Improving Belmont and Fountain Streets, Alexandria

Proposed shared crossing of Fountain Street

Engagement report

Proposed cycleway on Belmont Street accessing the shared path next to Alexandria Park Community School

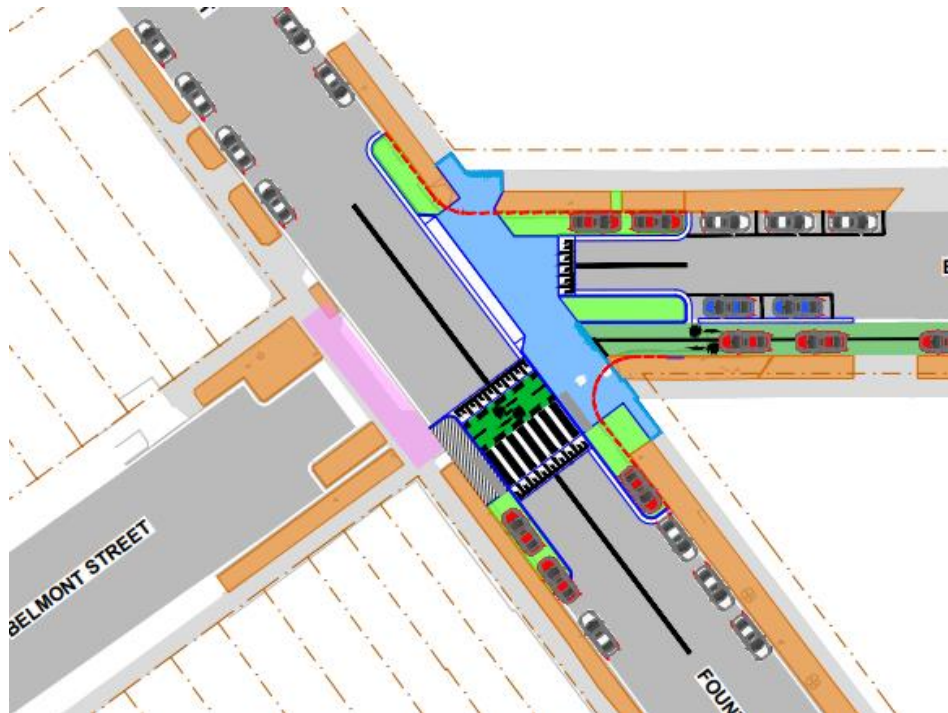
NSW Department of Education – School Infrastructure made a submission raising concerns about:

- The crossing on Belmont Street prioritises cyclists over vehicles, indicated by stop lines for vehicles on both approaches. This could pose a road safety risk, especially early on, as drivers may not realise they must give way to cyclists. The City of Sydney should install clear signage and road markings to alert motorists and reduce potential confusion or accidents.
- There is a potential conflict point where north–south cycling movement intersects with east–west student pedestrian flow to the school. Additional **signage warning pedestrians** about cyclists crossing the northern footpath should be considered.

They also asked that the City work with the school to make sure staff, students and parents are aware of the new infrastructure and road arrangements.

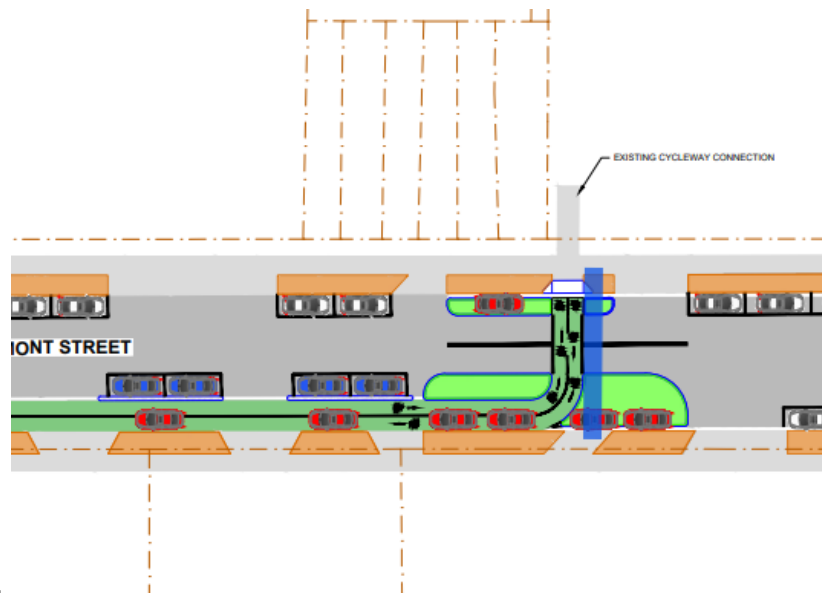
- The existing continuous footpath across the entrance to Belmont on the western side of Fountain needs to be marked as a shared path, and if necessary widened, to allow bikes of all shapes and sizes to navigate safely and legally to the shared user crossing. This area is shown in pink on the extract below. It is essential that no dismounting is required to cross Fountain Street.

- We note from the City of Sydney's Cycling Strategy Bike Network Map that there will be a local cycling connection east along Fountain Street. It is not clear which side of the road this may be located on. It is important to consider the future connection at this stage and adjust the kerb extensions, landscaped beds and shared paths as required to avoid the need for expensive and disruptive reconstruction in the future.
- The plans do not indicate how people walking up the south side of Belmont can cross the road to the shared path link to Buckland. Consider adjusting the configuration of the landscaping and the kerb ramps to the east of the cycleway crossing (as shown with the blue line in the extract below) to assist with pedestrian movements at this location

Without dimensioned plans and cross sections, it is not possible to assess the details of the project. The next two comments may already be addressed!

- Reduce the width of the vehicle lanes on Fountains Streets to the minimum acceptable for a road that carries buses - usually 3.2m. Unnecessarily wide traffic lanes invite motorists to drive at high speed. In addition to improving safety, a lower design speed will reduce traffic noise exposure for nearby residents.
- Widen the Belmont Streets cycleway as much as possible. The NSW Cycleway Design Toolbox minimum of 2.4m may not be adequate so close to a school where wide cargo bikes will be common.
